MDS SELF-STORAGE

RE: Mesa Del Sol Self Storage 5500 Turing Dr. SE Grading and Drainage Plan Engineer's Stamp Date: 5/7/2025 Hydrology File: R16DA1004

Re: Mesa Del Sol Self Storage 2322 Mesa del Sol SE Traffic Circulation Layout

MESA DEL SOL ARCHITECTURAL CONTROL COMMITTEE SITE DEVELOPMENT PLAN REVIEW

Sertil A. Kanbar

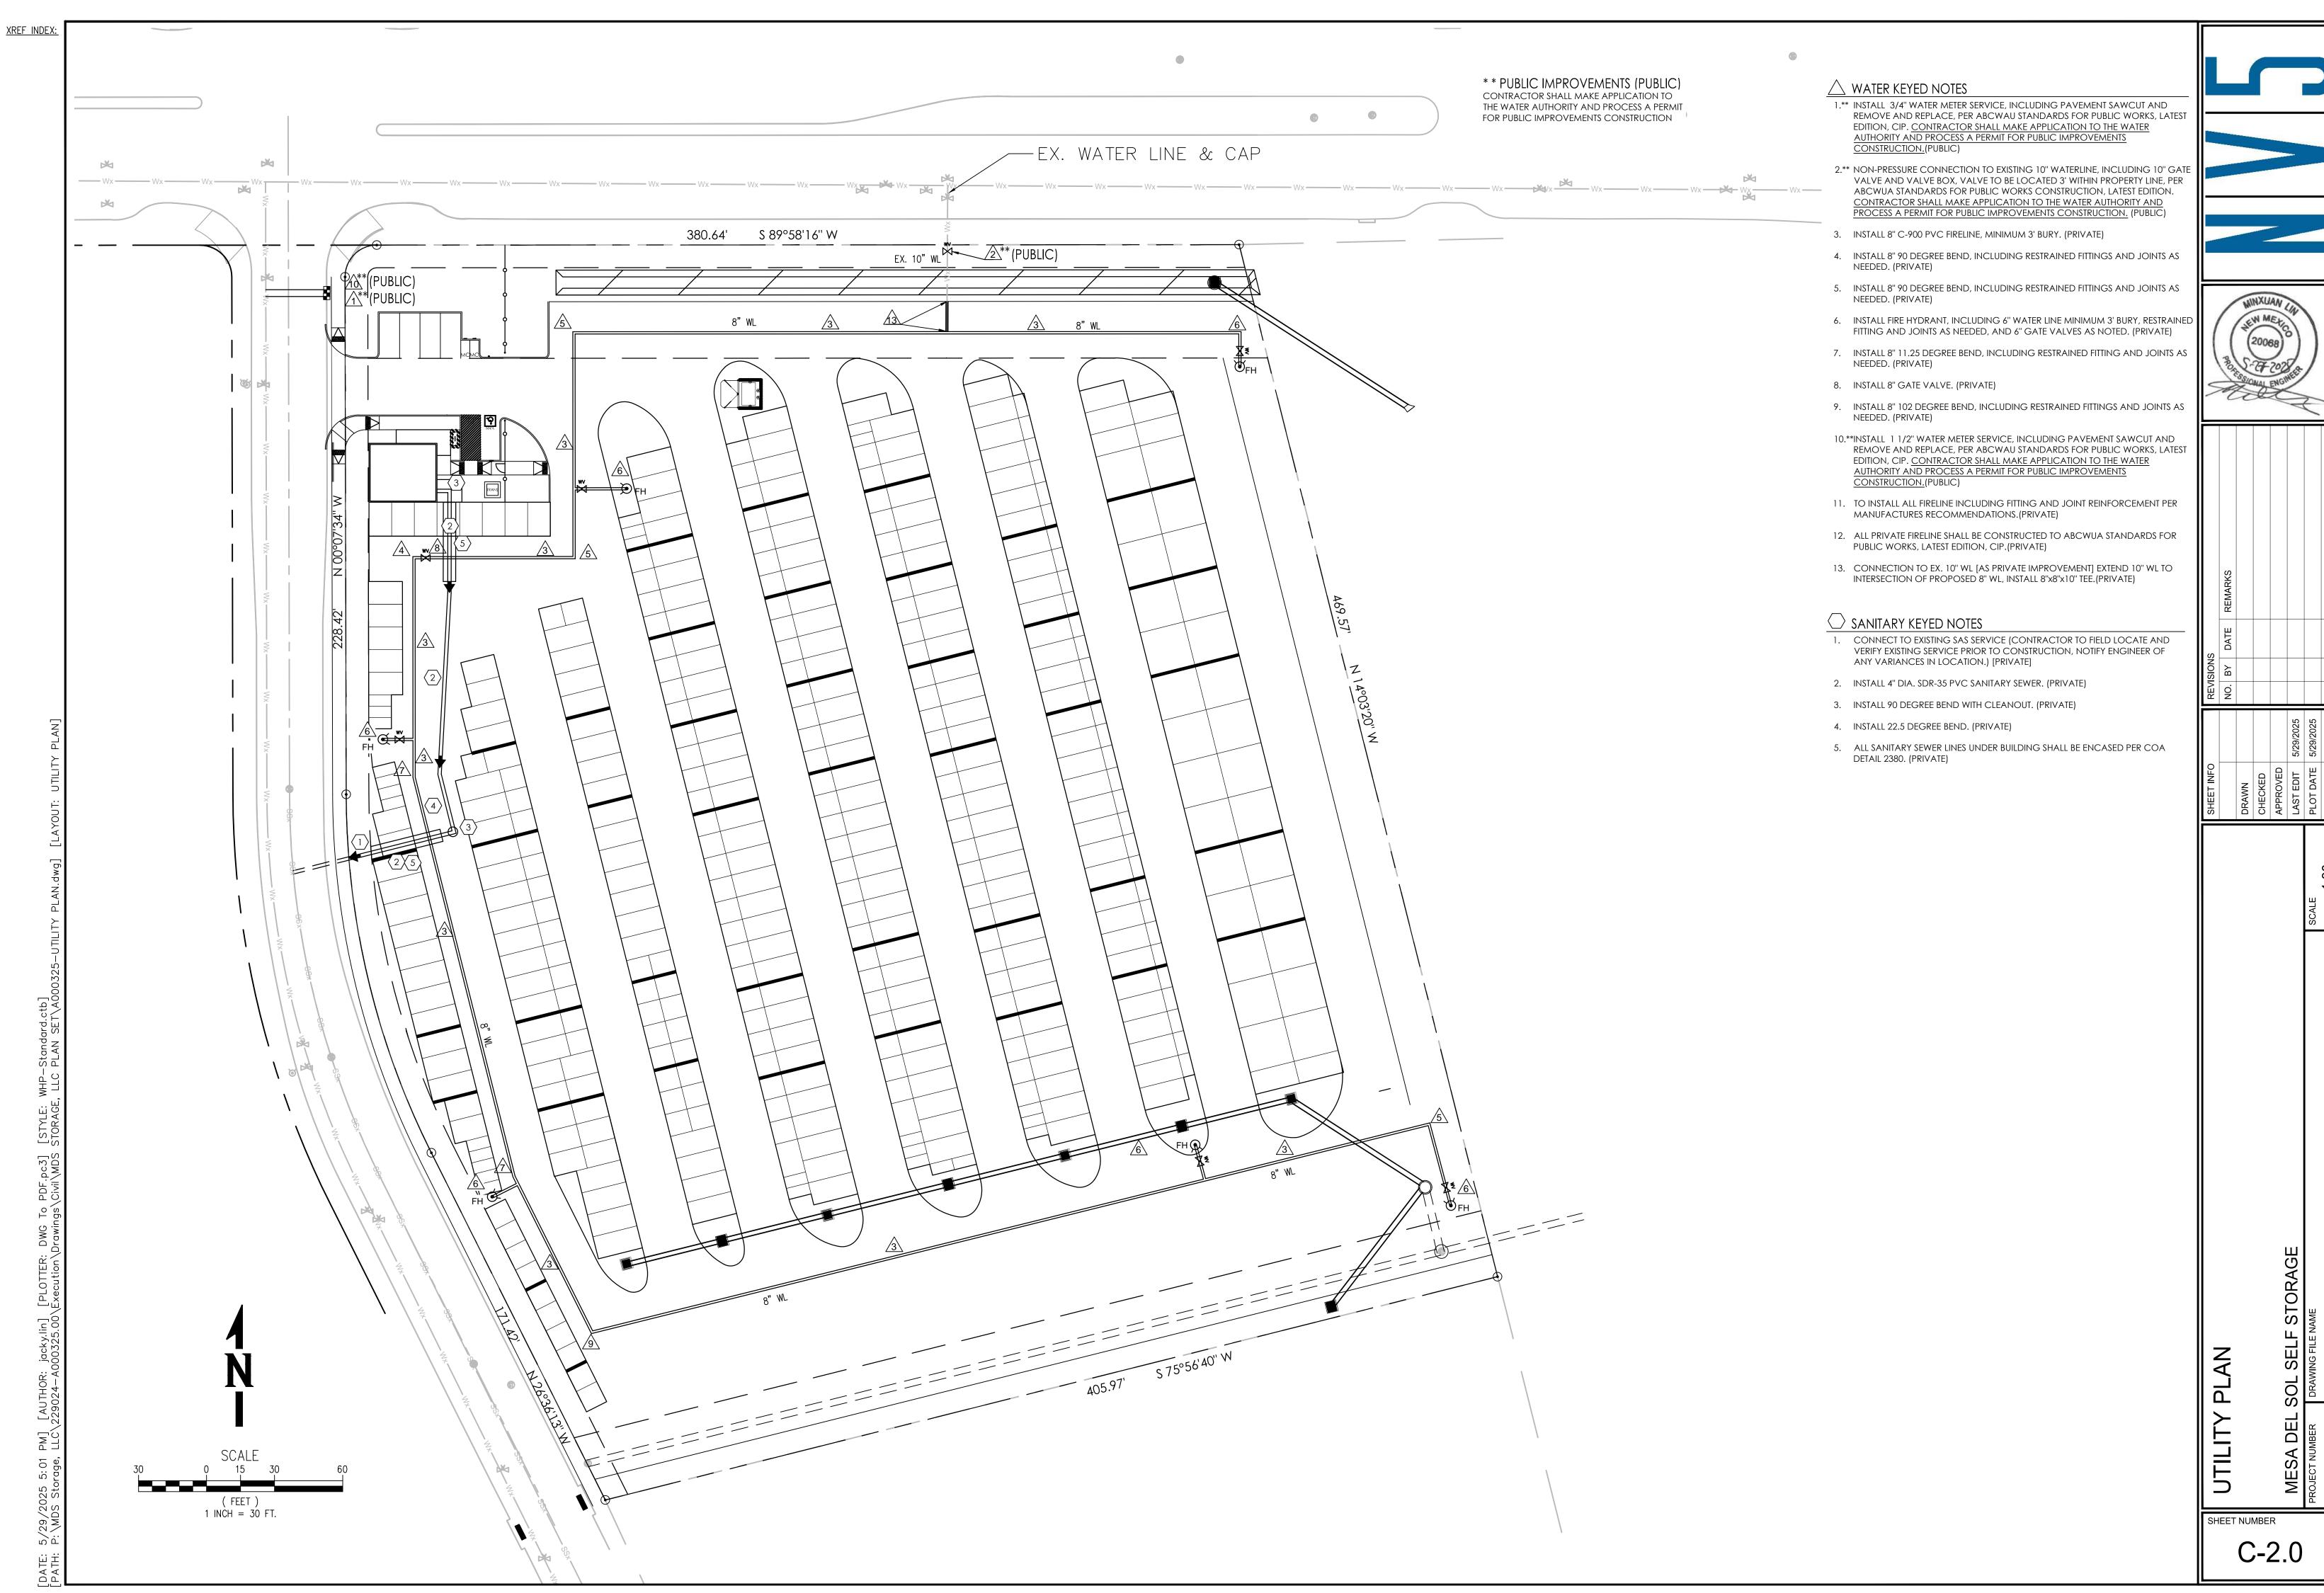
The TCL submittal received 9-23-2024 is approved for Building Permit by Transportation. A copy of the stamped and signed plan will be needed for each of the building permit plans. Please keep the original to be used for certification of the site for final C.O. for Transportation.

When the site construction is completed and an inspection for Certificate of Occupancy (C.O.) is requested, use the original City stamped approved TCL for certification. Redline any minor changes and adjustments that were made in the field. A NM registered architect or engineer must stamp, sign, and date the certification TCL along with indicating that the development was built in "substantial compliance" with the TCL. Submit this certification, the TCL, and a completed <u>Drainage and Transportation Information Sheet</u> to the <u>PLNDRS@cabq.gov</u> for log in and evaluation by Transportation.
